**CITY COUNCIL MEETING
OF THE CITY OF CEDAR HILLS
Tuesday, August 5, 2025 6:00 p.m.**

9. Review/Action on adopting a unique standard for Clear Vision Areas located at Canyon Heights Drive and Hillside Drive pursuant to City Code Title 10-5-17 *Presenter – Chandler Goodwin, City Manager*

SUBJECT:	Review/Action on adopting a unique standard for a clear vision area located at the intersection of Canyon Heights Dr and Hillside Drive, pursuant to City Code 10-5-17.
APPLICANT PRESENTATION:	Affected homeowners will be given the opportunity to make comments
STAFF PRESENTATION:	Chandler Goodwin, City Manager/Planner
BACKGROUND AND FINDINGS:	
<p>The intersection of Canyon Heights Drive and Hillside Drive meets the standards in City Code 10-5-17 Clear Vision Areas, allowing a unique standard to be adopted for this specific intersection relating to the clear vision area. The two roads intersect at an angle that varies significantly from a typical 90 degree angle, especially when evaluating the approach of Canyon Heights Drive heading westbound as it intersects with Hillside Drive. The topography, the curve, and existing landscaping make it very difficult for cars on Hillside Drive to see wes

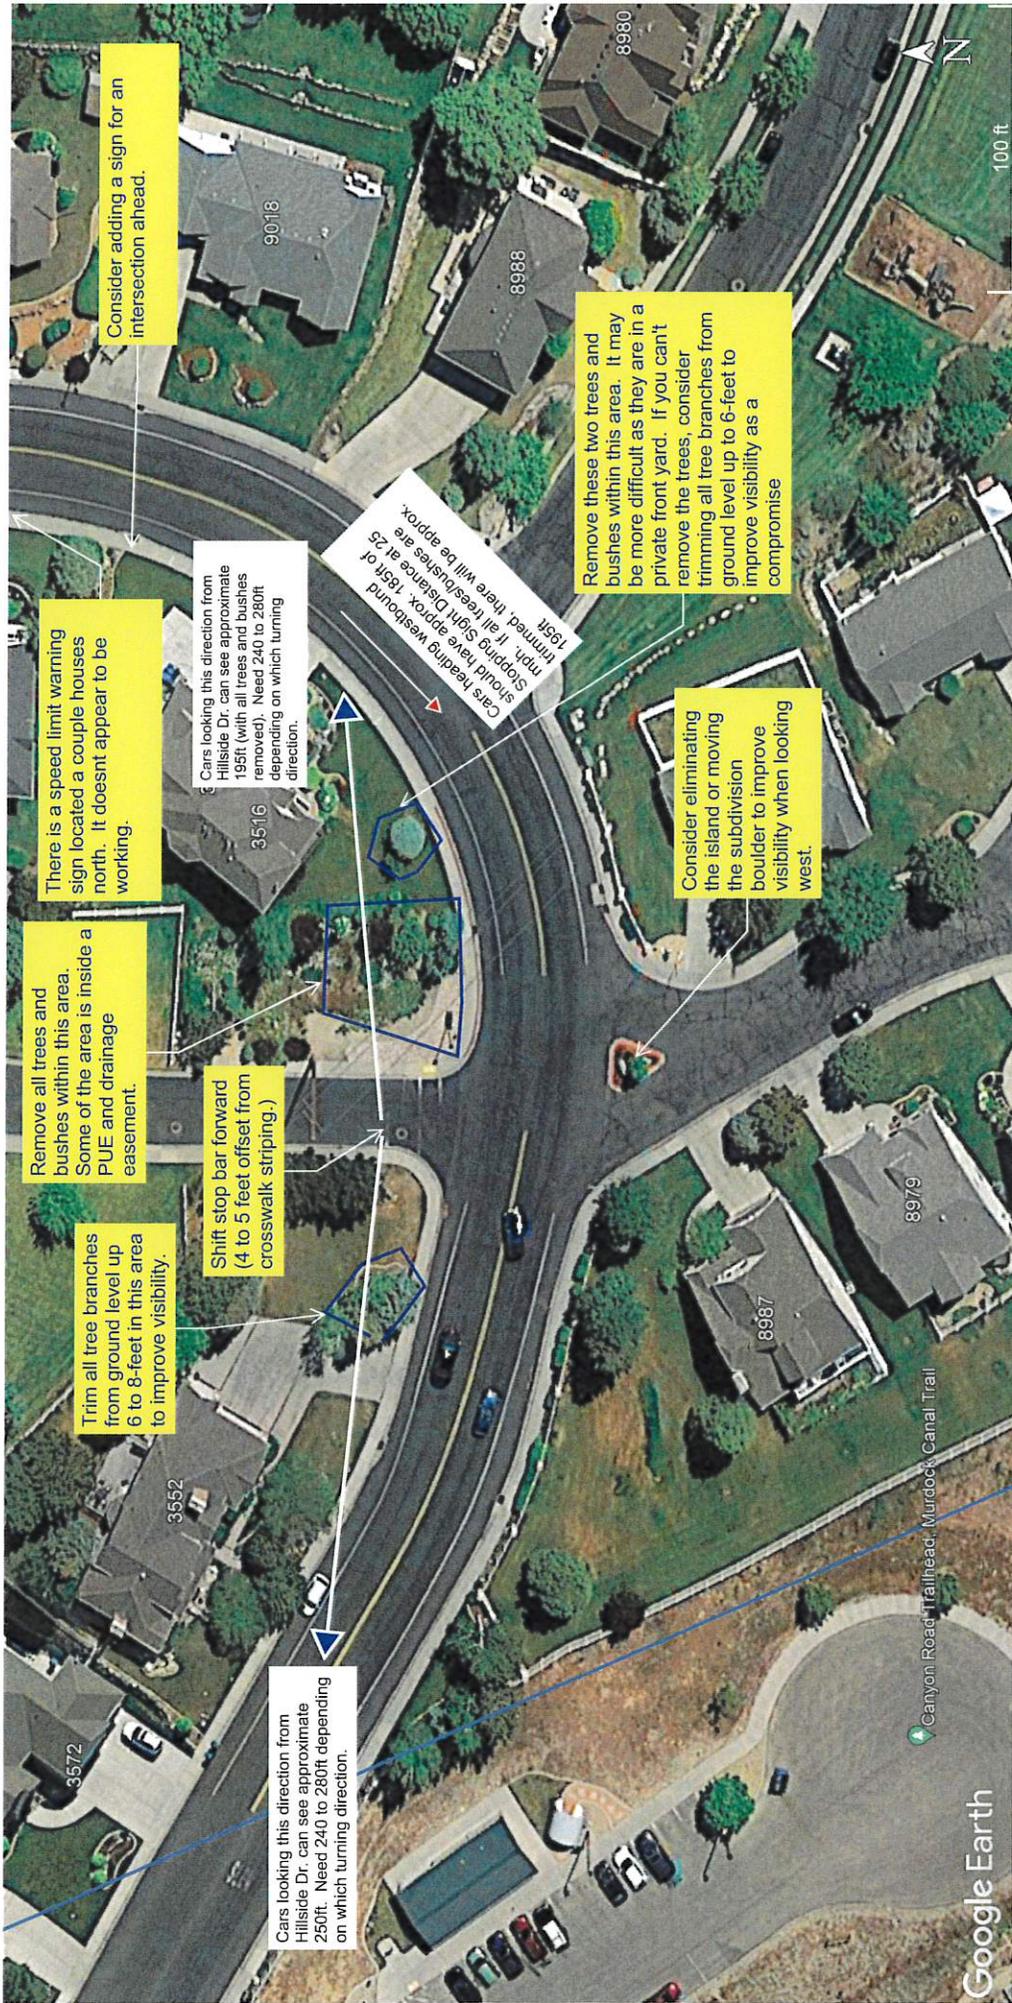
Consider adding a sign for an intersection ahead.

There is a speed limit warning sign located a couple houses north. It doesn't appear to be working.

Remove all trees and bushes within this area. Some of the area is inside a PUE and drainage easement.

Remove these two trees and bushes within this area. It may be more difficult as they are in a private front yard. If you can't remove the trees, consider trimming all tree branches from ground level up to 6-feet to improve visibility as a compromise
